DOE/EIS-0017

**Final Environmental Impact Statement**

**FUSION MATERIALS  
IRRADIATION TESTING  
FACILITY**

**Hanford Reservation  
Richland, Washington**

FIGURE 3.4-1. HFNS Liquid Waste Management System.

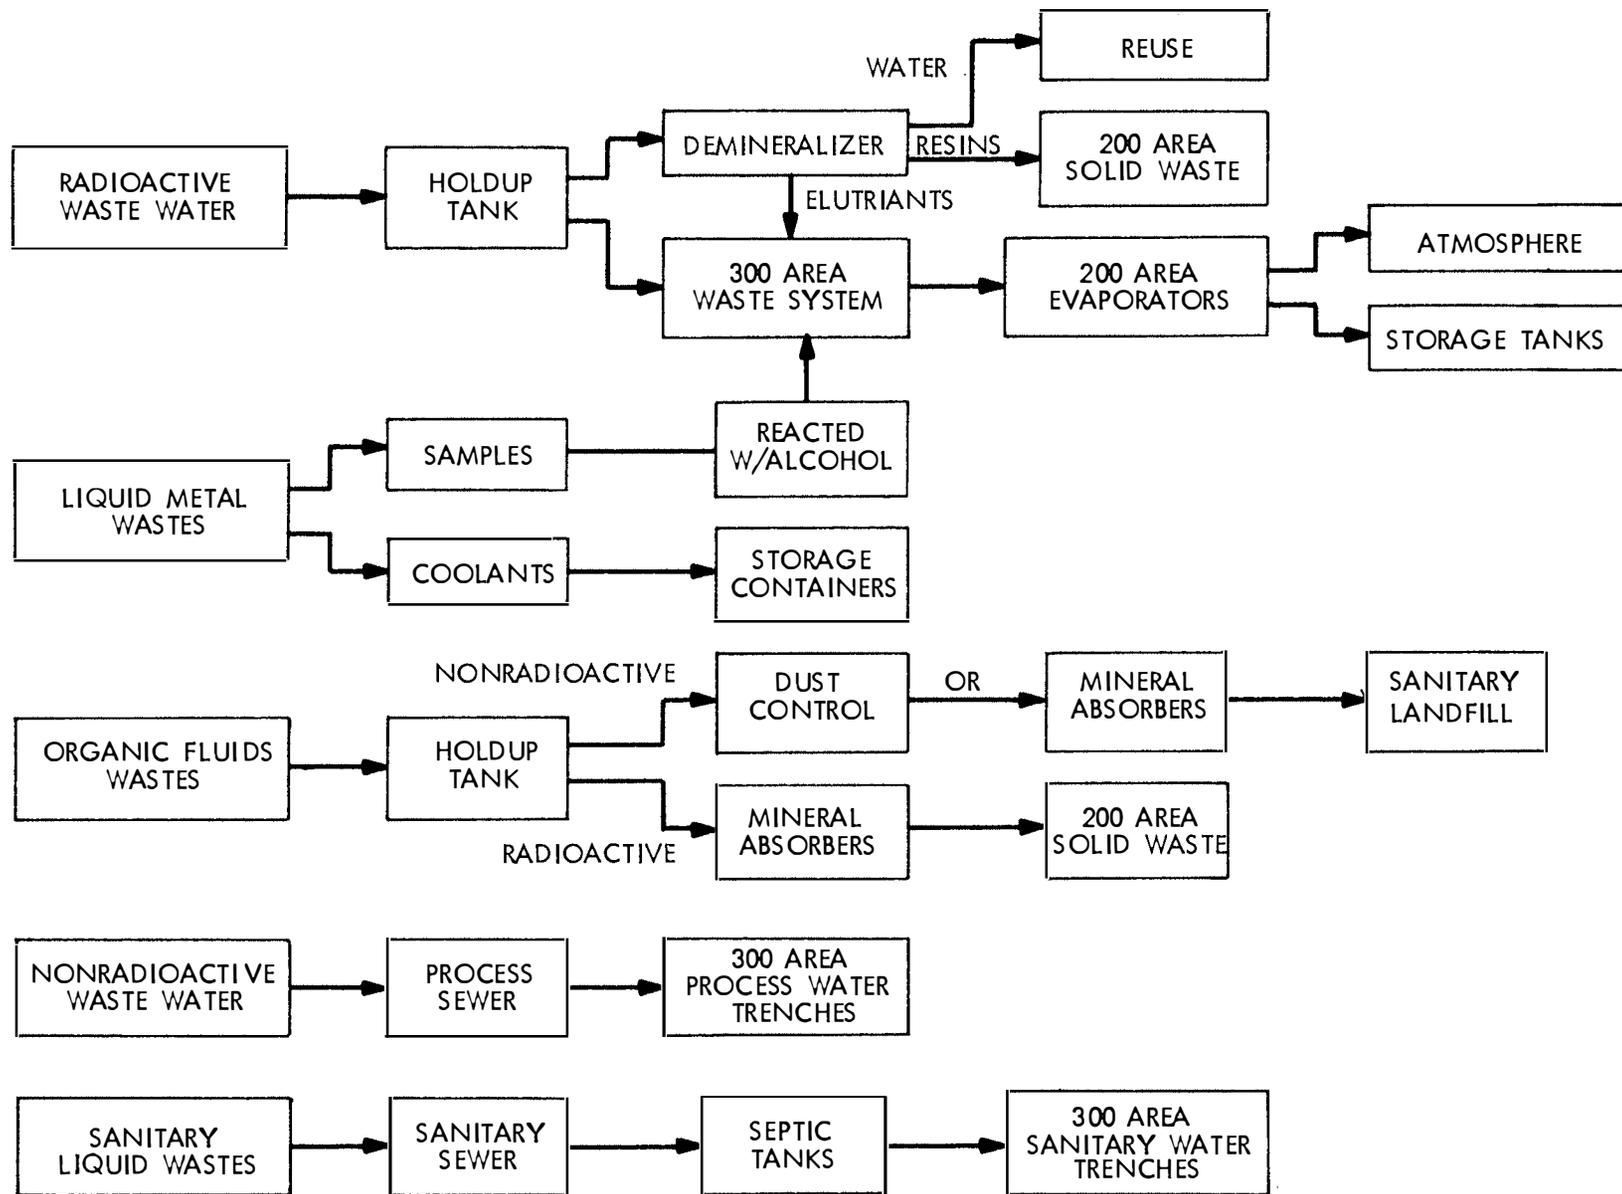
- B. According to figure 3.4-1, organic fluids waste will be used for dust control. What fluids will be used?  
How will they be applied?  
What will be their off-site impact?

FIGURE A.2-1. Land Use on the Hanford Reservation.

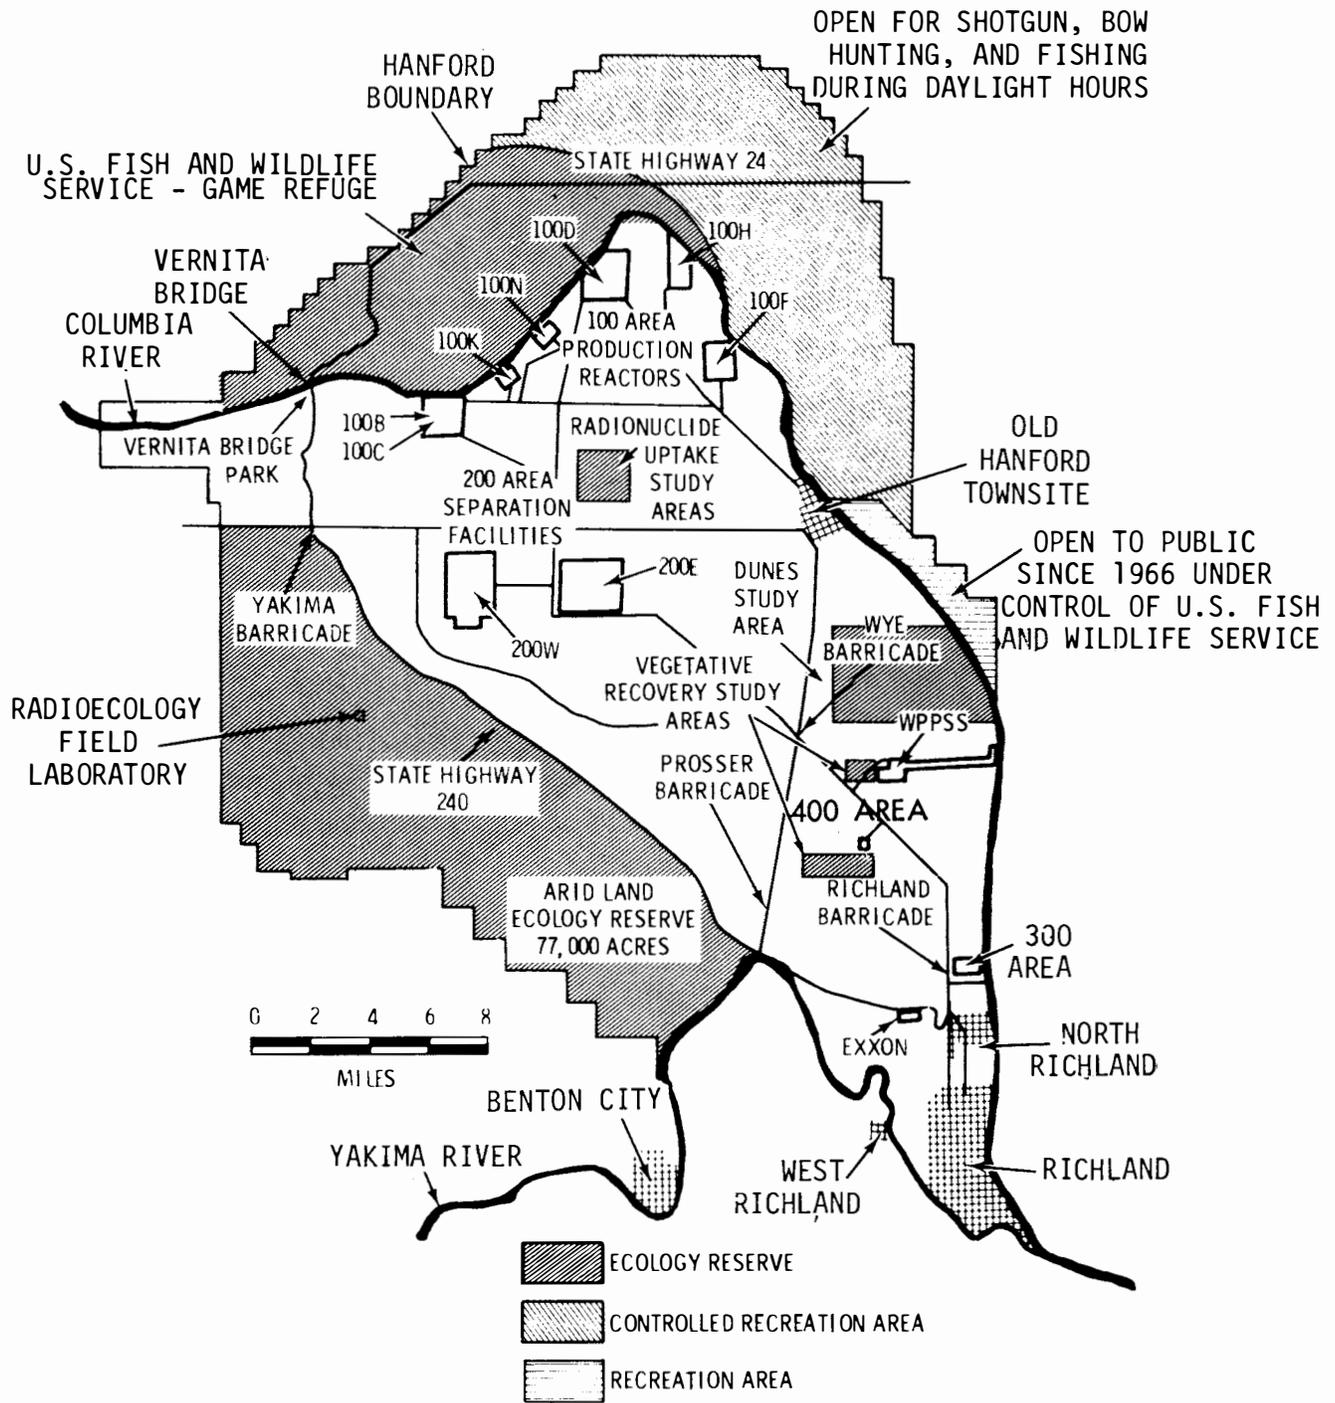
Page A-50, Figure A.2-1. The U.S. Fish and Wildlife Service is incorrectly identified as Bureau of Sport Fisheries and Wildlife. This should be corrected in the final statement.
